PLANNING APPROVAL,
PLANNED UNIT DEVELOPMENT &
SUBDIVISION STAFF REPORT

Date: November 19, 2009

St. Peter Subdivision

650 South Bayou Street
(Southwest corner of South Bayou Street and New Jersey Street, and extending to the North side of Montgomery Street and to the East side of Jefferson Street)

SITE PLAN

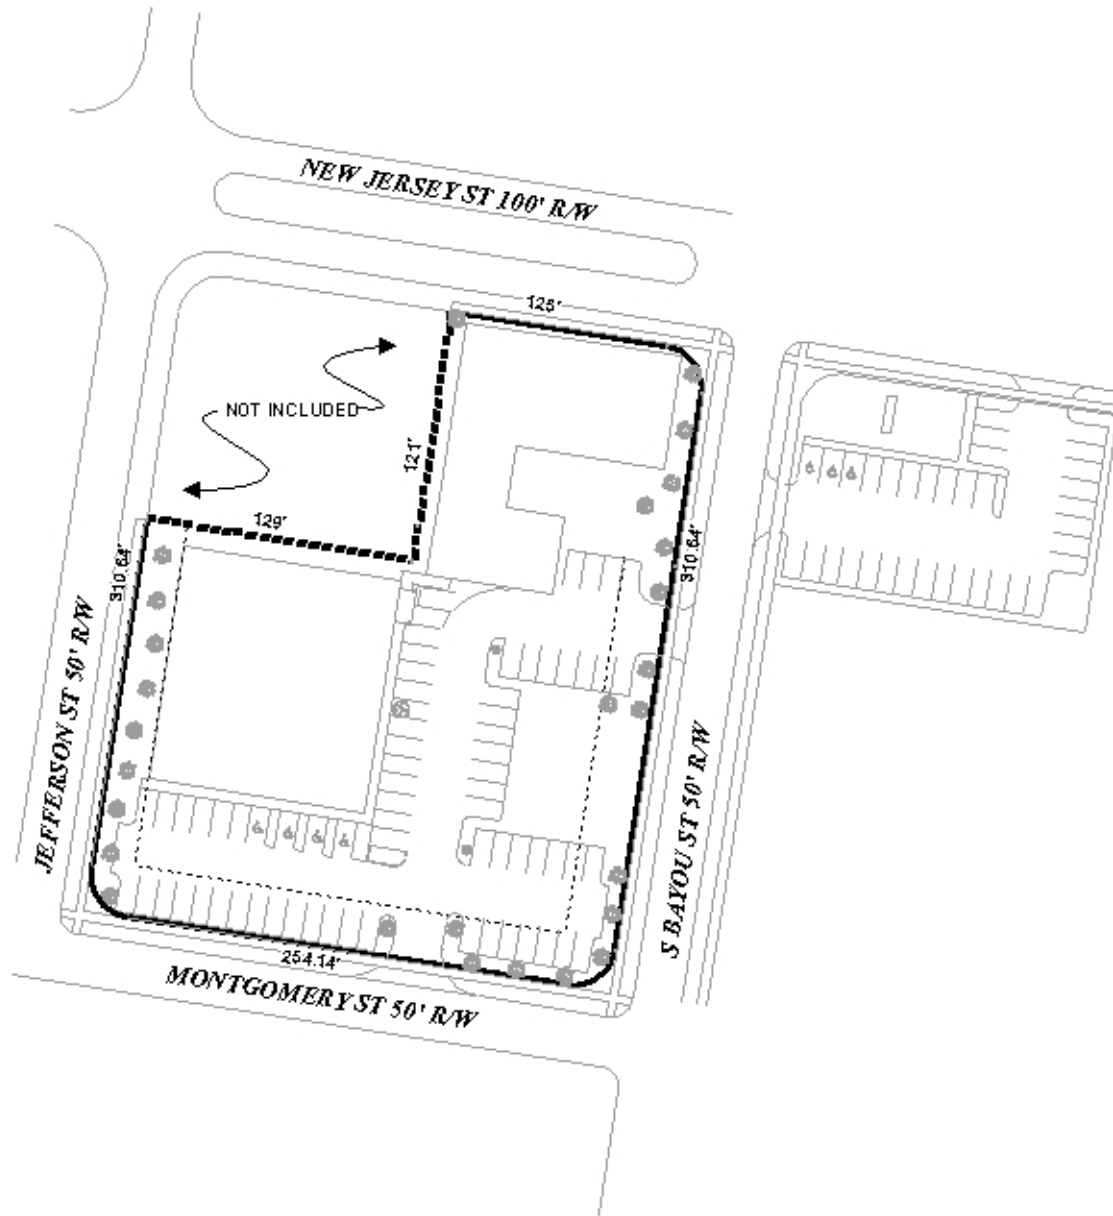
The area undergoing new construction should be brought into compliance with the Zoning Ordinance in terms of trees, landscaping, lighting and residential adjacency buffering. Thus, frontage trees should be provided along South Bayou Street (and are depicted on the site plan), and perimeter trees and a 6-foot high wooden privacy fence should be provided where the parking area abuts residentially developed properties. It should be noted that the wooden privacy fence should not exceed 3-feet in height where the fence is within 25-feet of a street right-of-way. The parking lot portions of the site should also comply with Section 64-6.A.3.i of the Zoning Ordinance for screening and landscaping requirements for parking lots with regards to buffer planting strips with a minimum height of 3 feet inside the street property line where they are across the street from residentially zoned property. Furthermore, as required by Section 64-6.A.3.c of the Zoning Ordinance, any lighting for the parking lots shall be so arranged that the source of light does not shine directly into adjacent residential properties or into traffic.

It should also be noted that Tree and Landscape data was noted on the plat for proposed lot 1. The applicant did not provide any Tree and Landscape data for the offsite parking lot, therefore, the site plan should be revised to show all Tree and Landscape data for both sites. The applicant

provided a note on the site plan of the lot size in square feet for proposed lot 1 but no note was provided for the lot size of the off site parking lot.

Dumpster locations for the site are not depicted on the site plan to comply with Section 64-4.D.9 of the Zoning Ordinance; therefore, the applicant should make a provision for dumpster locations and place a note on the site plan stating that dumpsters will be completely screened from view. If dumpsters will not be used, provide a statement indicating such, and how garbage will be removed from the site.

The 25-foot minimum building setback line is depicted on the plat and site plan on all street sides except for Jefferson Street. The applicant is proposing a 20-foot setback on Jefferson Street and states that they have submitted this request in their Variance application.

- 3) Depiction and provision of a 6-foot high wooden privacy fence around the perimeter of the site where it abuts existing residential development, with the exception of within 25-feet of a street right-of-way, where the fence shall not exceed 3-feet in height;

- 4) Provision of trees and landscaping for the off site parking lot area, to bring that portion of the site into compliance with the requirements of the Zoning Ordinance;

- 5) Depiction of dumpster locations on the site plan to comply with Section 64-4.D.9 of the Zoning Ordinance and placement of a note on the site plan stating that dumpsters will be completely screened from view or placement of a note stating how garbage will be removed;

- 6) Placement of a note on both site plans stating that lighting of parking facilities will comply with Section 64-6.A.3.c of the Zoning Ordinance;
- 7) Placement of a note on both site plans stating that the site will be in full compliance with screening and landscaping requirements for parking lots to comply with Section 64-6.A.3.i of the Zoning Ordinance;
